=====
PennDOT BQAD Publications e-Notification
Bureau of Design
Bridge Quality Assurance Division
=====

Interim Revision to Bridge Standard Drawing(s)	BD-612M, Shts. 2 & 3
--	---------------------------------

Interim Revision to Bridge Standard Drawing(s)	BD-632M, "R.C. Box Culvert", sheets 1, 3, 5, 9 and 10, dated 12/29/2008. Deeper Inlet Apron Cutoff Walls, Impervious Wingwall Backfill and Multiple Opposing Apron Baffles.
--	---

Interim Revision to Bridge Standard Drawing(s)	BD-632M, "R.C. Box Culvert", sheets 1, 4, 5, 9 and 10, dated 12/29/2008. Clarification of Backfill Material - Type, Placement Limits and Preformed Drain at Weep Holes.
--	---

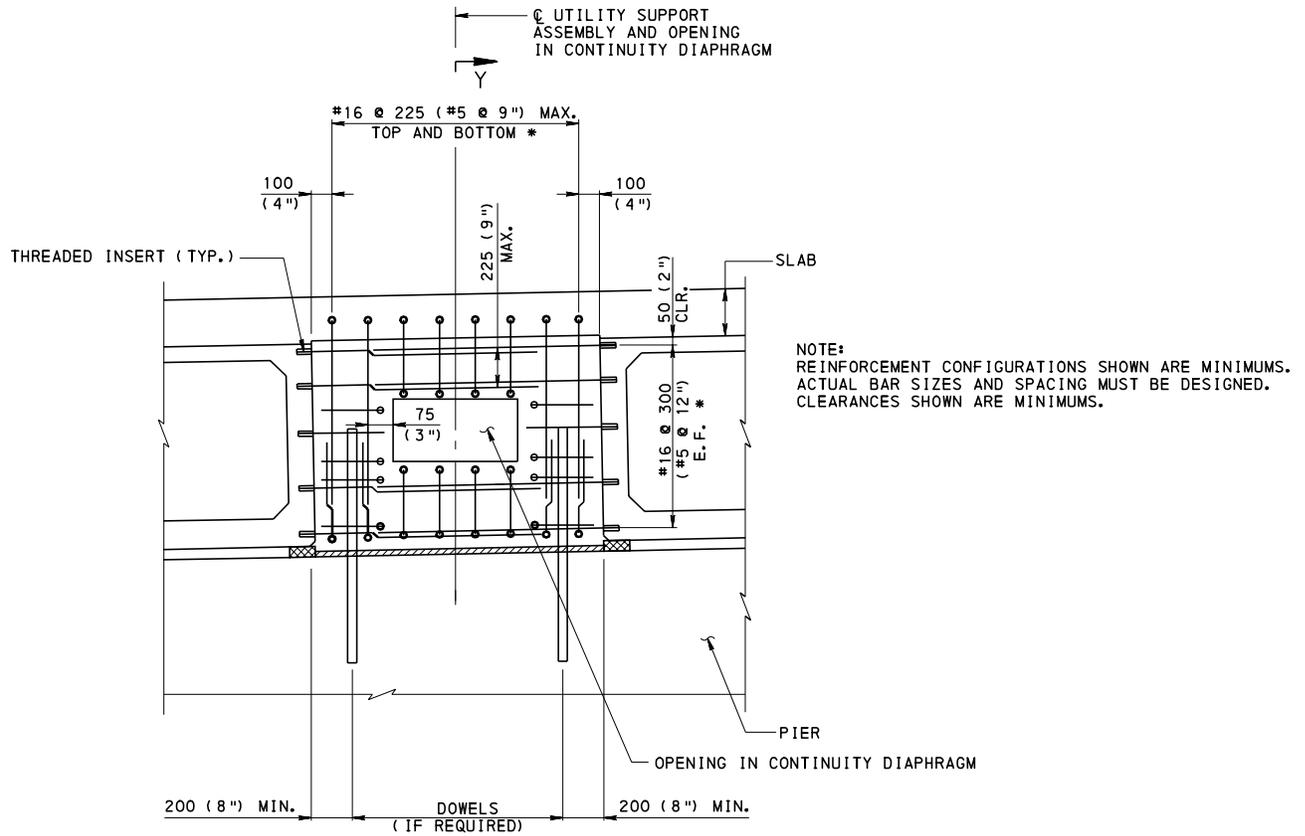
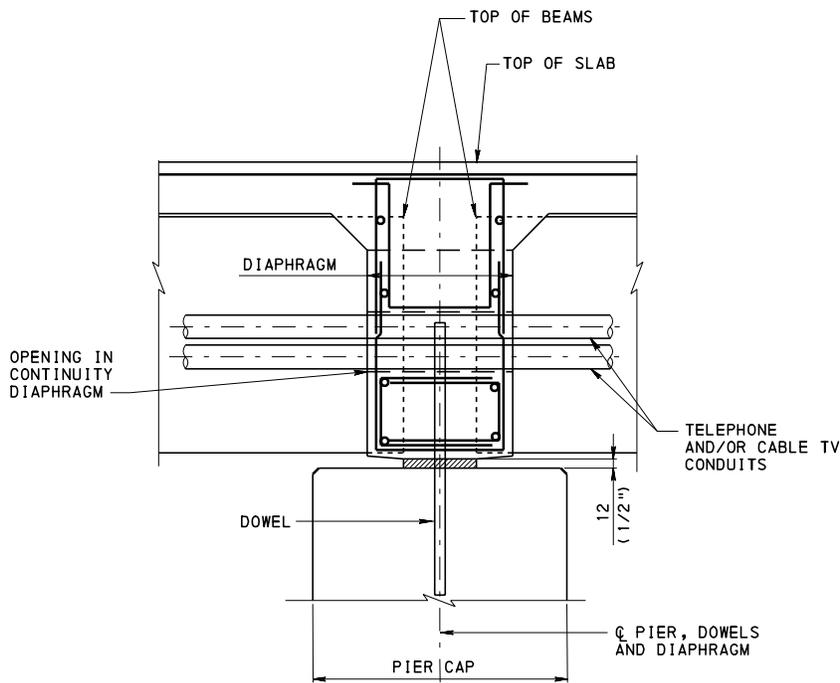
See the following two sheets for revised details from Sheets 2 & 3 which have the special confinement reinforcement around the dowel bars removed per Seismic Strike-off Letter 431-02-05, dated May 23, 2002.

Publication No. 218M
Standard: BD-661M
RE: Sheets 1, 2, and 6
No. 4
Date: 6-20-03
=====

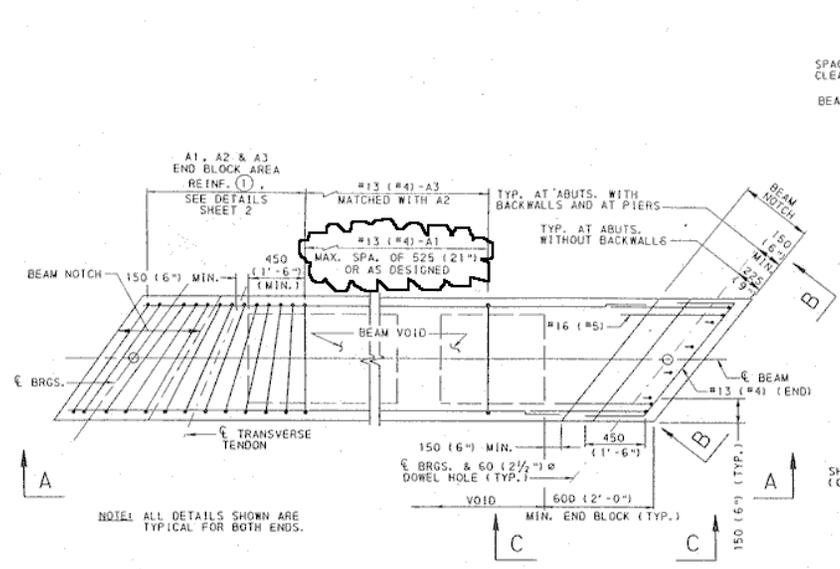
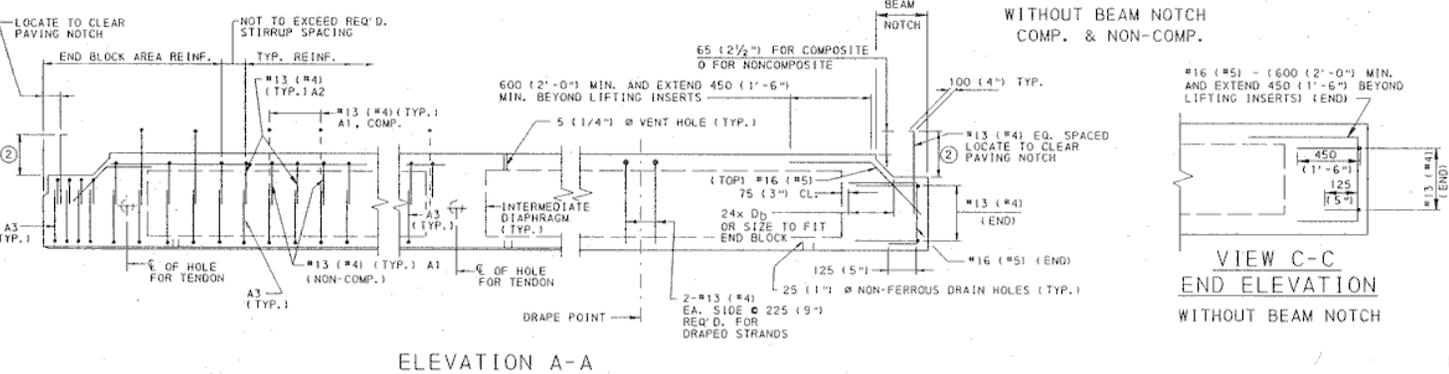
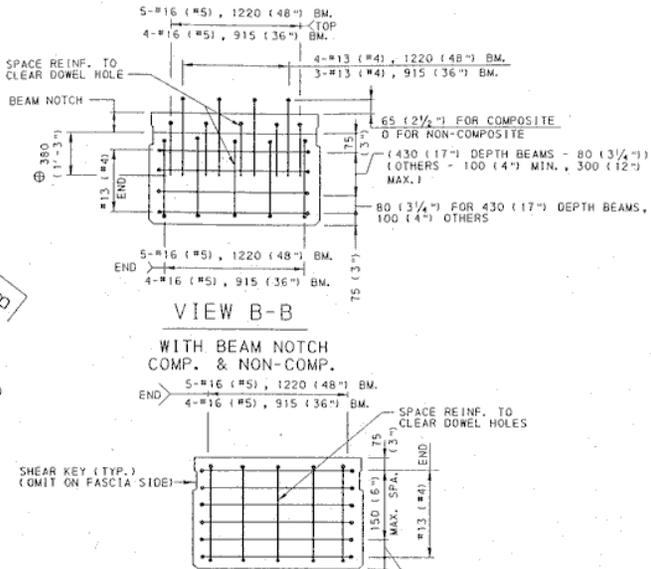
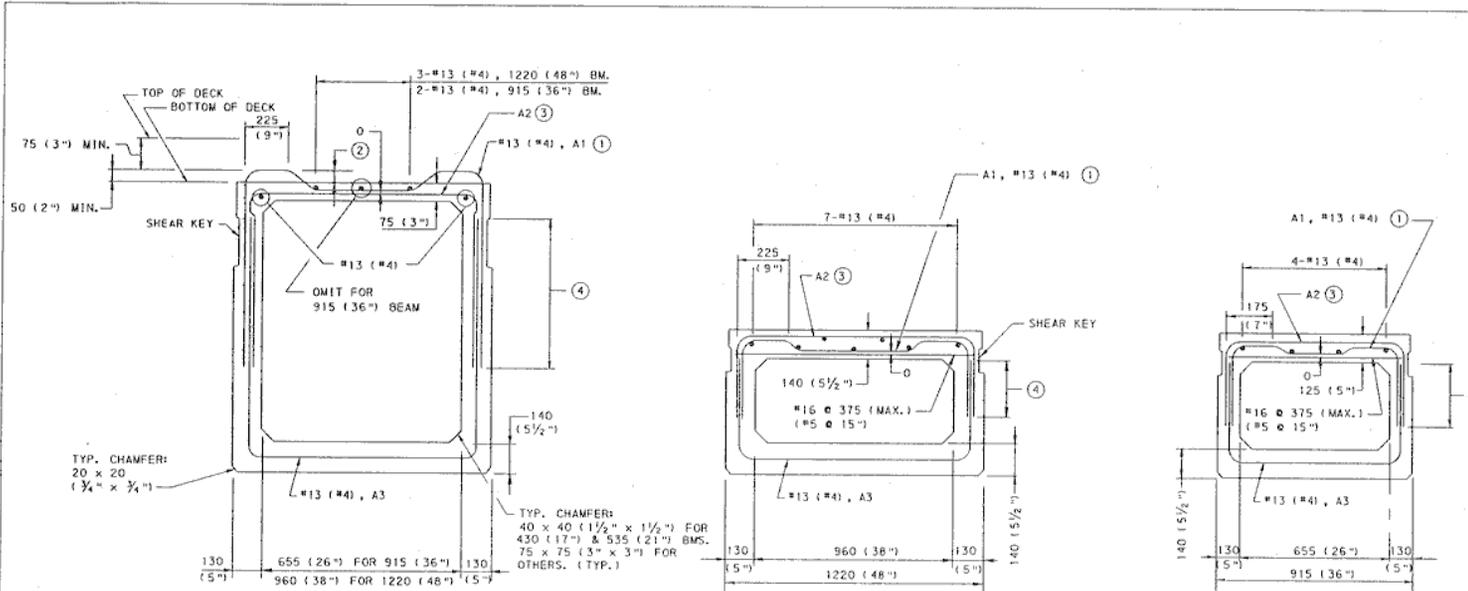
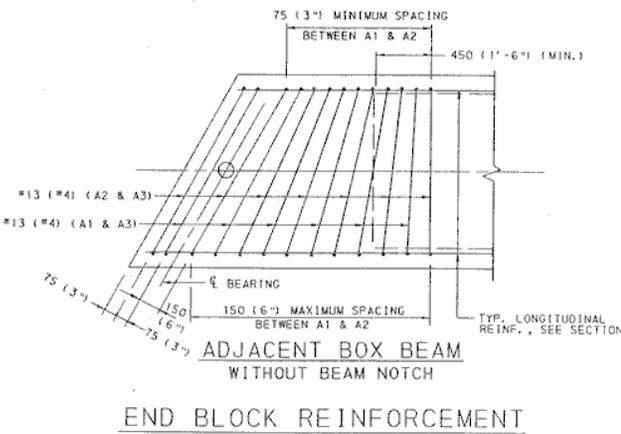
Revise the stirrup spacing from 525 (21") to 530 (21") as indicated on the attached Adobe Acrobat PDF File.

ELEVATION – POST DETAIL has the following revisions and clarifications:

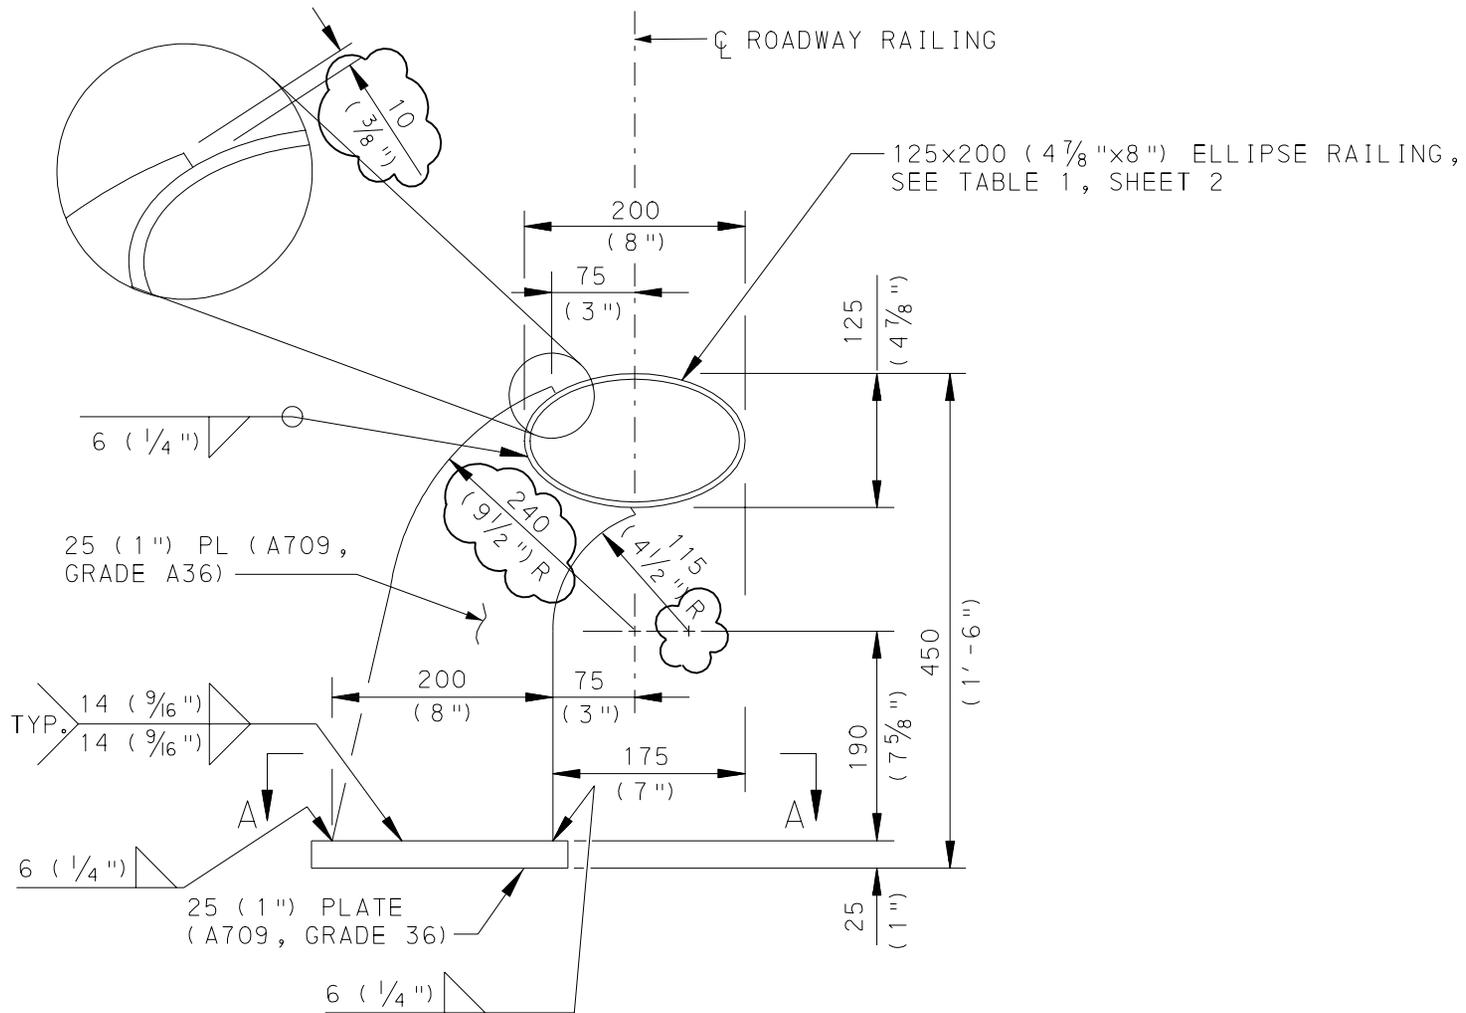
- A. REVISE THE EXISTING OUTER EDGE POST RADIUS OF 250 (10") R TO INDICATE 240 (9 1/2 ") R. CENTER POINT TO BE LOCATED AT 75 (3") FROM INSIDE EDGE OF POST PLATE AND 190 (7 5/8") FROM BOTTOM EDGE OF POST PLATE.
- B. REVISE THE POST PLATE DIMENSION IN THE TOP RIGHT BLOW-UP VIEW FROM 6 (1/4") TO 10 (3/8").
- C. CLARIFY THE CENTER POINT OF THE 4 1/2 INCH INSIDE RADIUS OF POST PLATE.

THIS DETAIL IS INCLUDED ON THE NEXT SHEET AND THE REVISIONS ARE CLOUDED.

Interim Revision to Bridge Standard Drawing(s) – No. 9	BD-632M, Sht. 5 - Revised Joint Detail
--	--

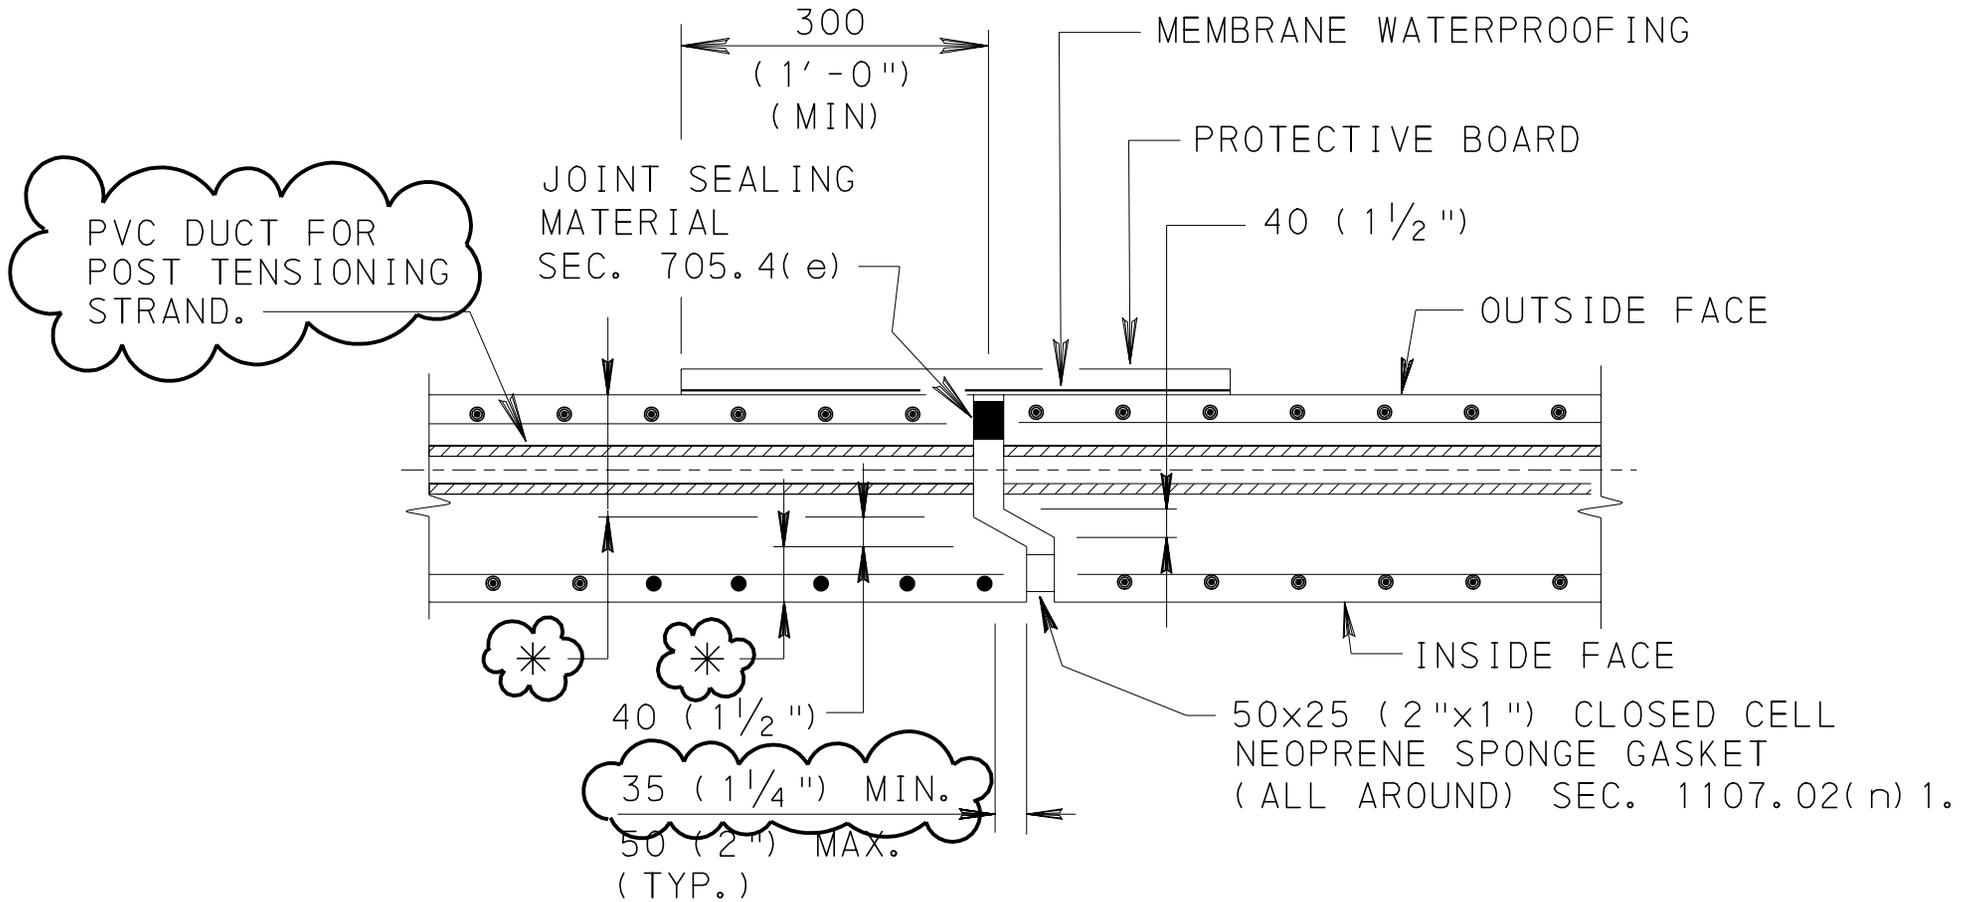
JOINT DETAIL has the following revisions and clarifications:

- A. Added PVC Duct for Post Tensioning Strand detail to drawing.
- B. Changed 40 min. / 50 max. dimension to 35 min. / 50 max.
- C. Removed SEE NOTE 24 SHEET 4 references and added note (*) beneath Details title. Increased thickness break point used to determine perpendicular surface width of joint from 300 (1'-0") to 350 (1'-2").

OPTIONAL POSITIVE MOMENT CONNECTION
DETAIL AT PIER

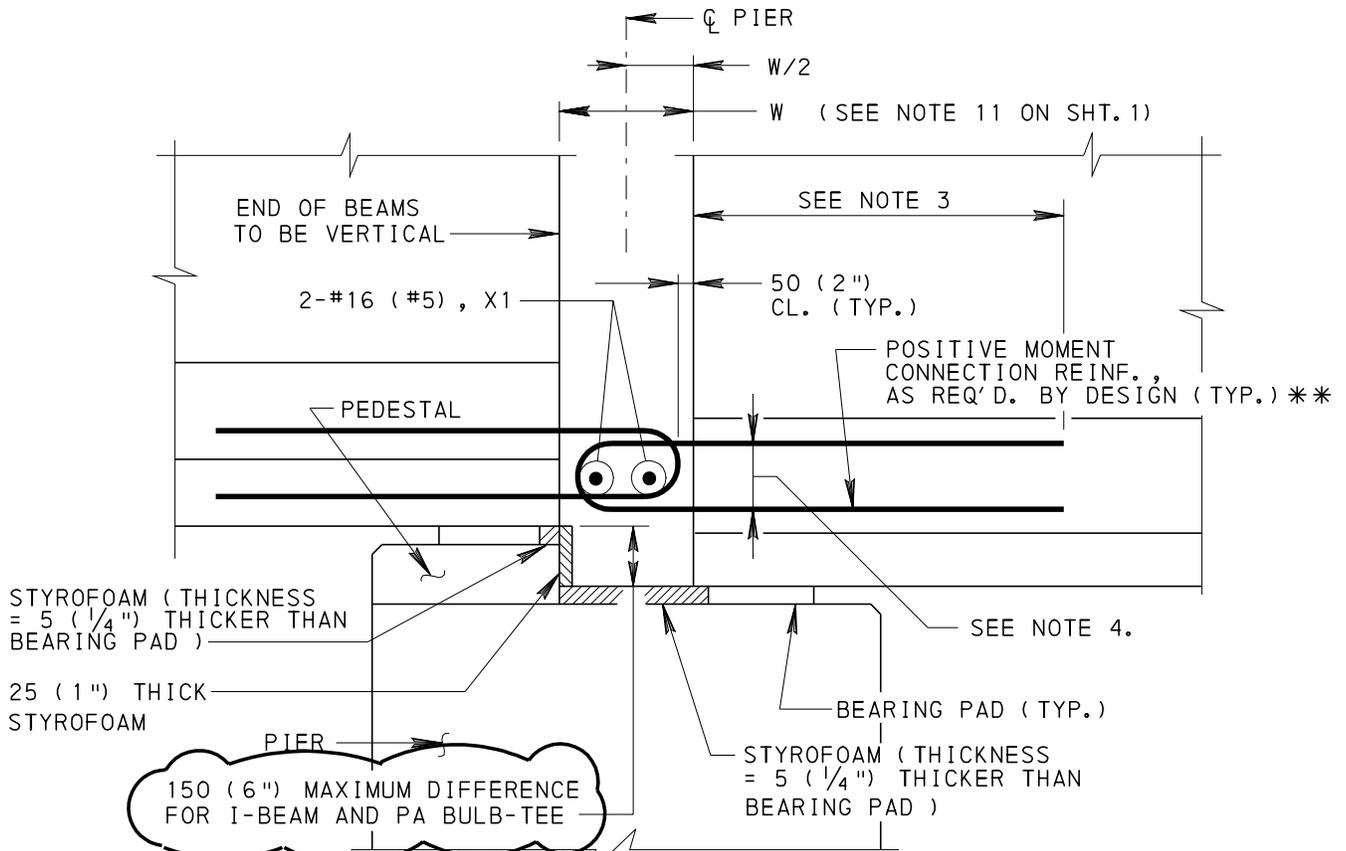
In OPTIONAL POSITIVE MOMENT CONNECTION DETAIL AT PIER: Added maximum height difference of 200 (8”) for adjacent span PA Bulb-Tee prestressed concrete beams. This correction is shown in the attached 8.5”x11” page.

BD-632M, dated July 20, 2007, Sheet 7 – SECTION A-A: Revision of Anchor Bolt Bar Size embedded in slab, railing tube size and number of longitudinal rebars required in parapet.

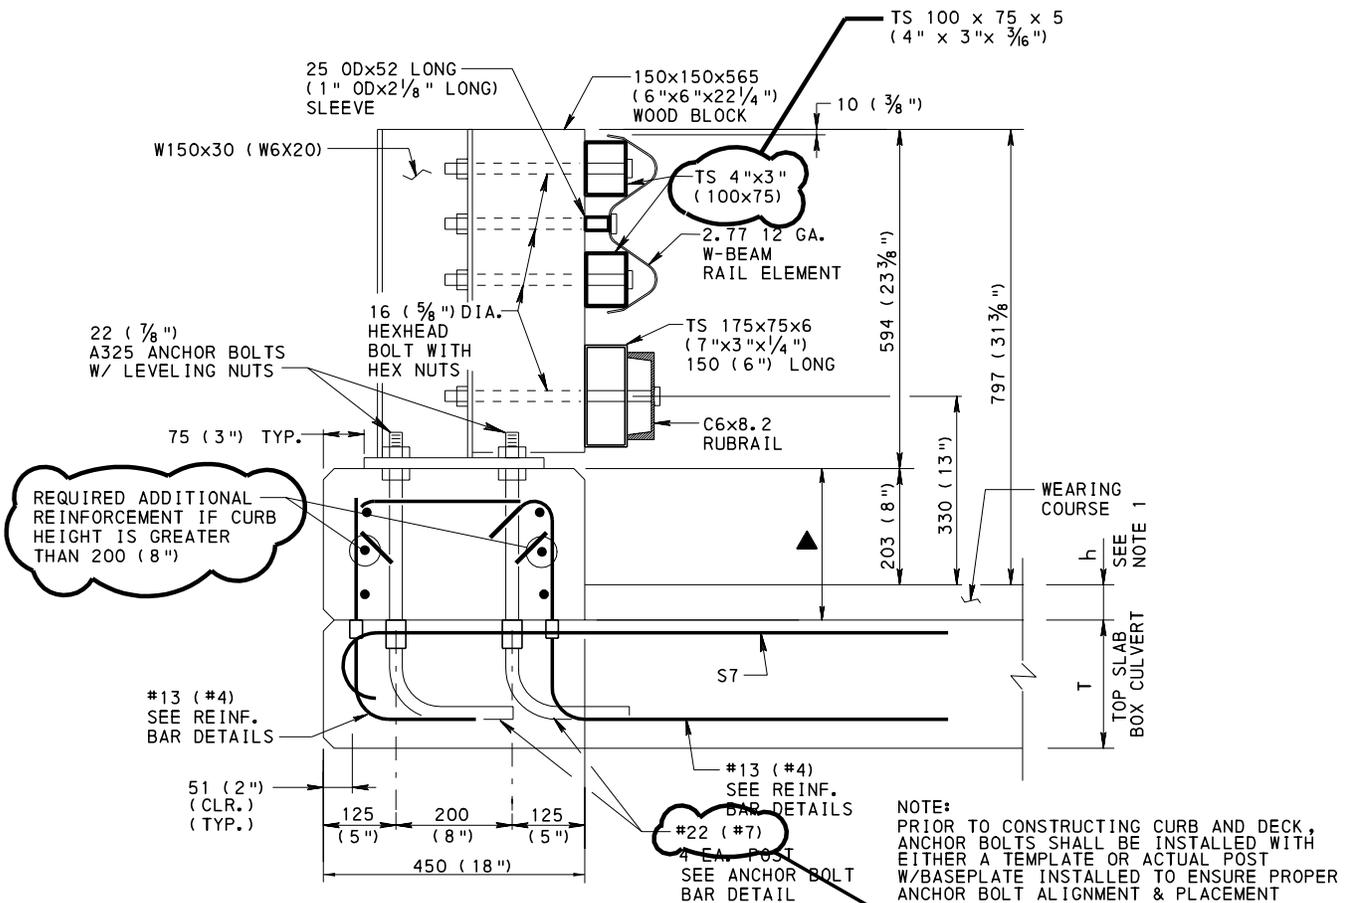
In Section A-A of BD-632M, Sheet 7:

- Revise size of anchor bolt bar embedded in the slab from #22 (#7) to #19 (#6).
- Add "x 3/16" to thickness of top railing tube.
- Add the following call-out for longitudinal reinforcement in barrier's concrete parapet:

Interim Revision to Bridge Standard Drawing(s)	BD-667M, dated July 20, 2007, Sheet 6 – APPROACH SLAB CONNECTION DETAILS: Replacing “BOND BREAKER” with “circled Note 12 - COAT WITH EPOXY BONDING COMPOUND...”.
--	---

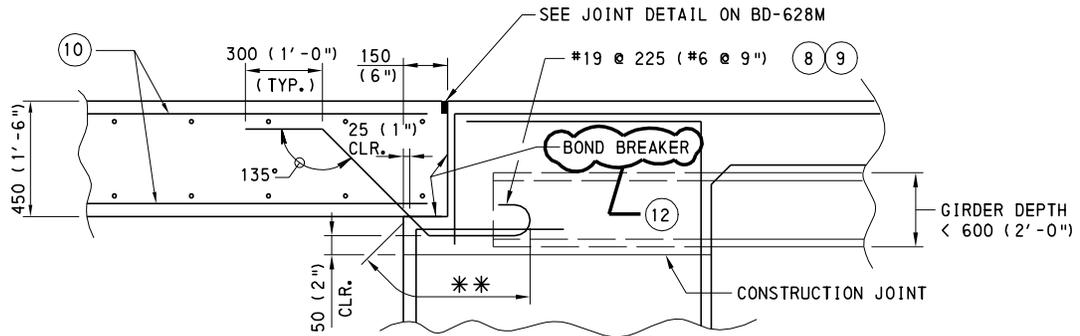
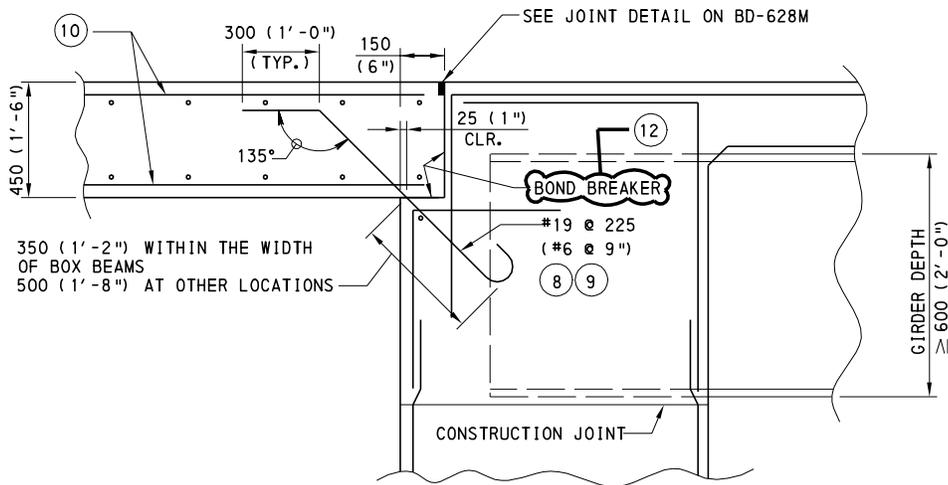
In the two (2) Approach Slab Connection details of BD-667M, Sheet 6:

- Replace “BOND BREAKER” with circled Note 12 which is explained below.

Add circled Note 12 to LEGEND and make it read as follows:

COAT WITH AN APPROVED EPOXY BONDING COMPOUND PRIOR TO PLACING APPROACH SLAB CONCRETE.
